STAFF REPORT: 2/17/2021 MEETING PREPARED BY: D. RIEDEN, J. ROSS APPLICATION NUMBER: #21-7049

ADDRESS: 700 SEWARD

SCOPE: WALL VENTS (WORK DONE WITHOUT APPROVAL)

West Elevation, by Applicant: Location of current work without permit elevation at a location not in proposed drawings. See also photograph above.

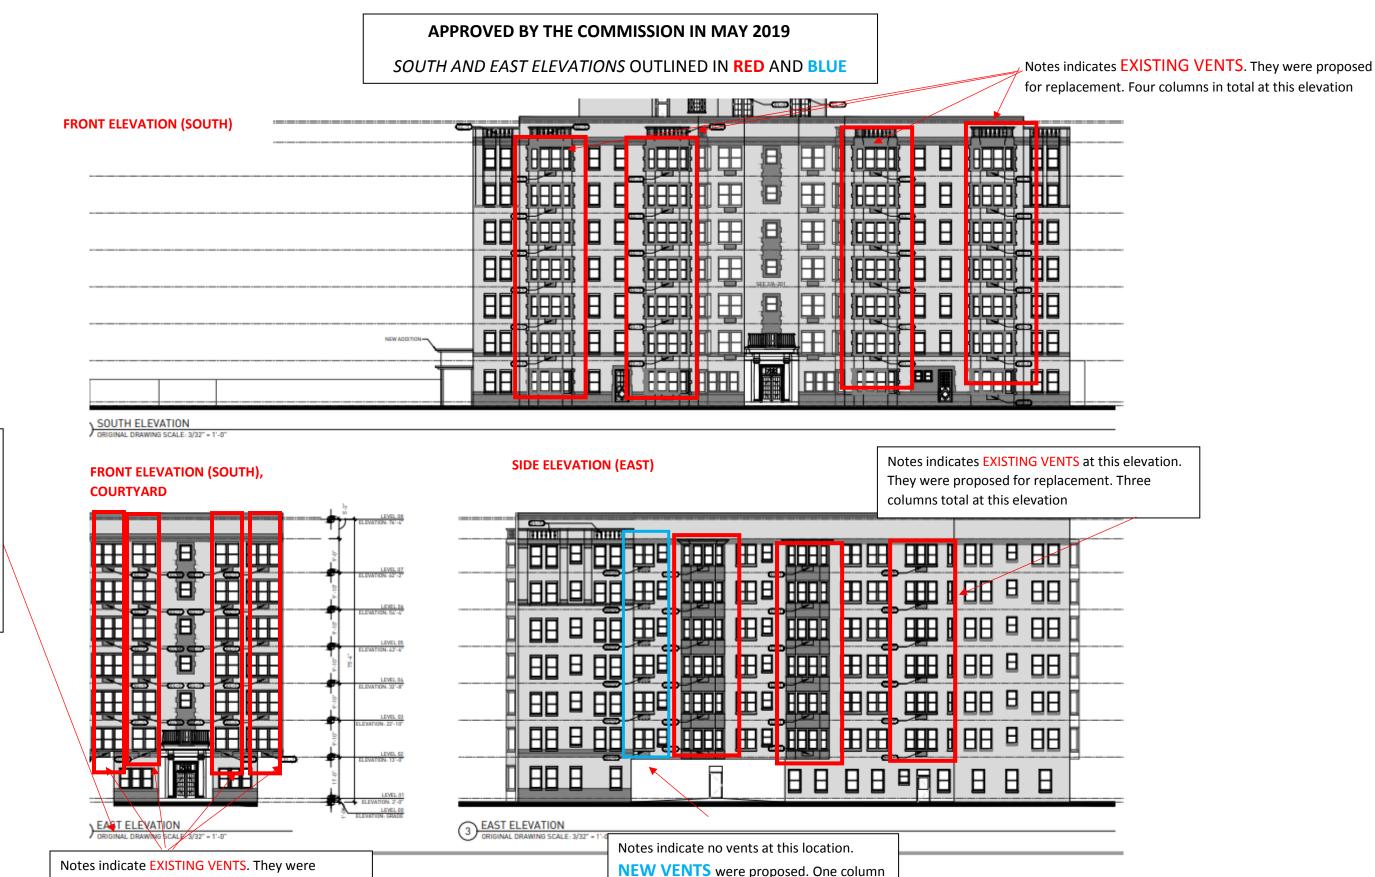
Site Photo 3 by Staff February 7, 2021: West elevation showing work without approval at a location not in proposal drawings. See also diagram, below.

- The applicant has added new vent openings to the west elevation, towards the rear of the wall without approval. These openings were not approved in 2019, nor do they appear in the drawings submitted with the current proposal

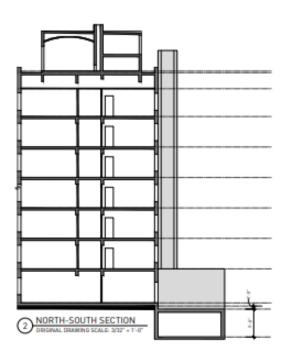
Current application states that these vents are EXISTING and are proposed for replacement. Yet, 2019 drawing indicates that they were new. COMMISSION APPROVED NEW VENTS AT THIS LOCATION IN 2019

Staff states new vents being added at this location in violation of HDC approval. New vents at the location are not indicated in either the 2019 or 2021/current drawings. HDC has not approved this work

Current application states that these vents are EXISTING and are proposed for replacement. Yet, 2019 drawing does not show vents at this column

COURTYARD AT FRONT (WEST ELEVATION)

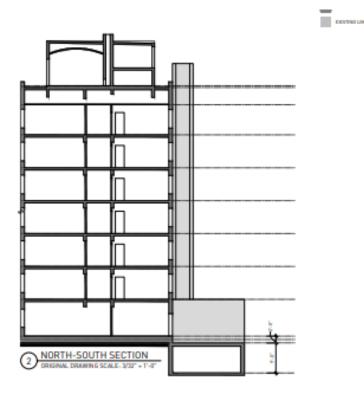
Notes indicates **EXISTING VENTS** at this elevation which were **APPROVED BY THE COMMISSION IN 2019. NEW VENTS** are proposed at these two columns (outlined in yellow) WITH THE CURRENT 2021 PROPOSAL.

COURTYARD AT FRONT (EAST ELEVATION)

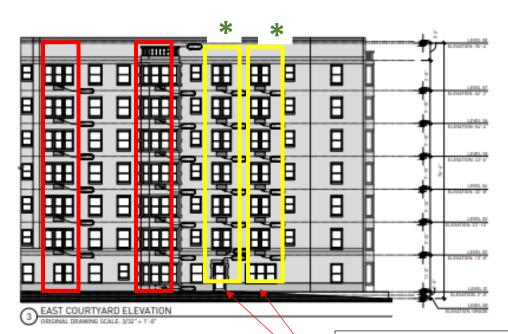
Notes indicates **EXISTING VENTS** at this elevation which were **APPROVED BY THE COMMISSION IN 2019**.

Current application states that these vents are EXISTING and are proposed for replacement. Yet, 2019 drawing does not show vents at this column
